National Committee on Uniform Traffic Control Devices

Markings No. 1

Markings Crosswalk Markings Approved by Markings, January 2011 Distributed as sponsor ballot, Spring 2011 FHWA high visibility crosswalk marking study Section 3B.18

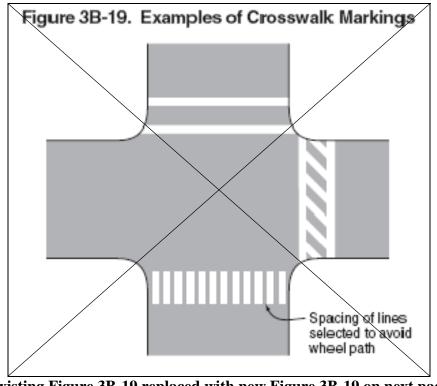
104-109 (¶ 15)	• Text added to provide guidance on dimensions, especially for bar pairs.
130-131 Fig 3B-17	• Figure 3B-17 has been revised to a high-visibility crosswalk marking pattern instead of a basic crosswalk marking pattern.
134 Fig 3B-19	• Existing Figure 3B-19 replaced with new Figure 3B-19

Figure 3B-19. Examples of Crosswalk Markings [New Figure 3B-19 to replace existing figure]

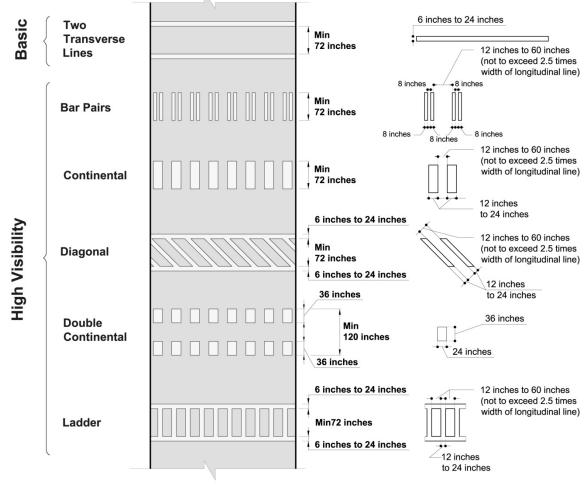
Line No.	Explanation
13-16 (¶ 4)	Editorial change
18-22 (¶ 4.1)	 Paragraph 4.1 has been added to introduce types of crosswalk marking patterns.
	• Figure 3B-19 was revised to show several types of crosswalk marking patterns and distinguish between basic and high-visibility crosswalk markings.
	 Bar pairs added because several states/cities (e.g., Seattle, Dallas) are now using them and recent FHWA study found similar detection distances to continental and bar pairs. <u>http://www.fhwa.dot.gov/publications/research/safety/pedbike/10068/10068</u>
	<u>.pdf</u>
